PETITION NO:	Z-86
HEARING DATE (PC):	12-02-14
HEARING DATE (BOC): _	12-16-14
PRESENT ZONING:	R-15
PROPOSED ZONING:	RA-5
PROPOSED USE: Single-F	amily Subdivision
SIZE OF TRACT:	17.789 acres
DISTRICT:	18
LAND LOT(S):	
PARCEL(S):	43
TAXES: PAID X DU	J <b>E</b>
COMMISSION DISTRICT	<b>:</b> 4
	HEARING DATE (PC): HEARING DATE (BOC): PRESENT ZONING: PROPOSED ZONING: PROPOSED USE: _Single-F  SIZE OF TRACT: DISTRICT: LAND LOT(S): PARCEL(S):

APPLICANT: Zero One, LLC	PETITION NO.:	Z-86
PRESENT ZONING: R-15	PETITION FOR:	RA-5
* * * * * * * * * * * * * * * * * * * *	* * * * * * * * * * * * * * *	* * * * * * * * * *
ZONING COMMENTS: Staff Member Responsi	ble: Jason A. Campbell	
Land Use Plan Recommendation: Low Density Resid	dential (1-2.5 units per acre)	<u> </u>
Proposed Number of Units: 47 Overa	all Density: 3.02 Uni	ts/Acre
Staff estimate for allowable # of units:27(per Z-187 of 2005 *Estimate could be higher or lower based on engineered plans taking in natural features such as creeks, wetlands, etc., and other unforeseen circu	nto account topography, shape of I

#### **Z-86** ZERO ONE, LLC

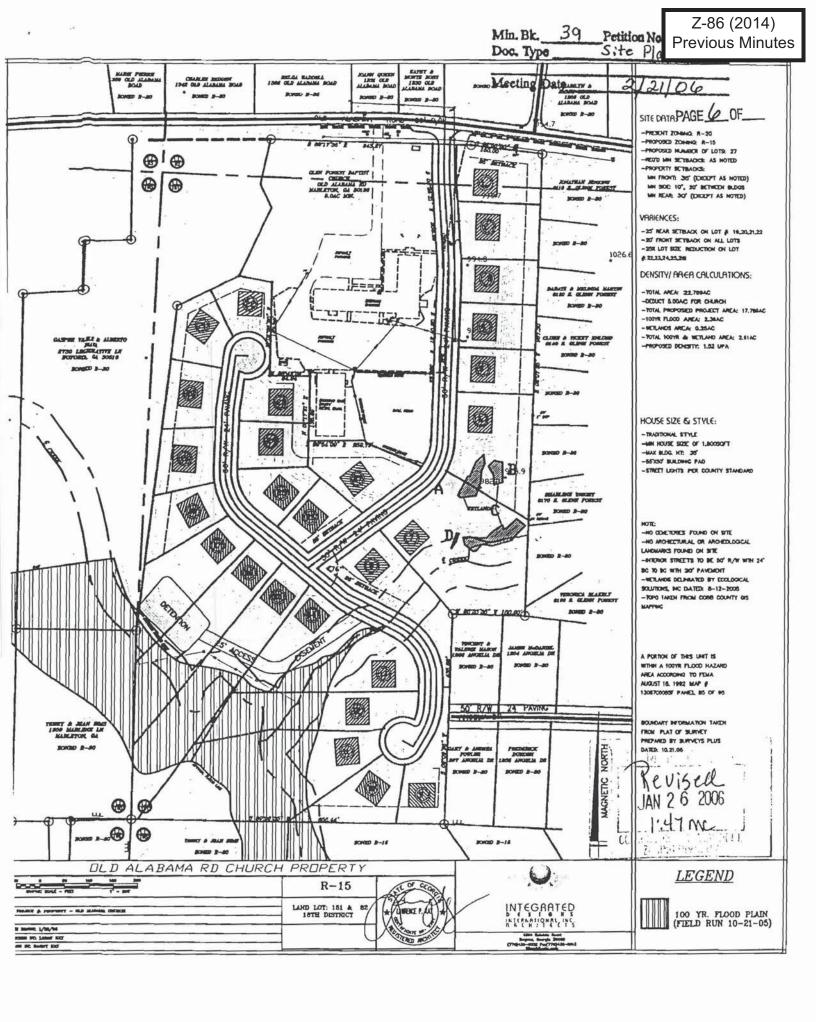
On February 7, 2006, the Planning Commission recommended approval of the above-styled zoning application to the R-15 and R-20 zoning category and added the matter to the Board of Commissioners consent agenda for February 21, 2006. My client has revised the site plan as attached to place the proposed detention facility on an independent lot. My client is also revising numbered paragraph 9 of the stipulations to reflect an additional agreement with an adjoining property owner regarding plantings to update the density calculation by removing some property on the other side of the creek from the density calculation. The revised stipulations and the revised site plan will supersede all previous stipulations and site plans.

- 1. The rezoning request is revised to R-15 with 27 homes.
- The homes shall have a minimum of 1,800 square feet of climate controlled living space.
- All homes shall be single family detached homes with a minimum of a two car attached garage.

- 4. In order to minimize the grading on the site, my client requests a front setback variance to reduce the front setback to 20 feet throughout the development.

- 5. The developer requests a contemporaneous variance on lots 19, 20, 21 and 22 to allow for a 25 foot rear setback.
- A contemporaneous lot size variance on lots 22, 23, 24, 25 and 26. However, the average lot size in the development exceeds 28,000 square feet.

- In order to accommodate the request of Vincent Mason who resides at 1266
   Angelia Drive, the road has been shifted eastward to prevent backyards from facing Mr. Mason's property.

- 8. During the plan review process, the developer shall provide a sewer easement from Mr. Mason's property to a sewer manhole in the vicinity of the creek behind lots 7 and 8.
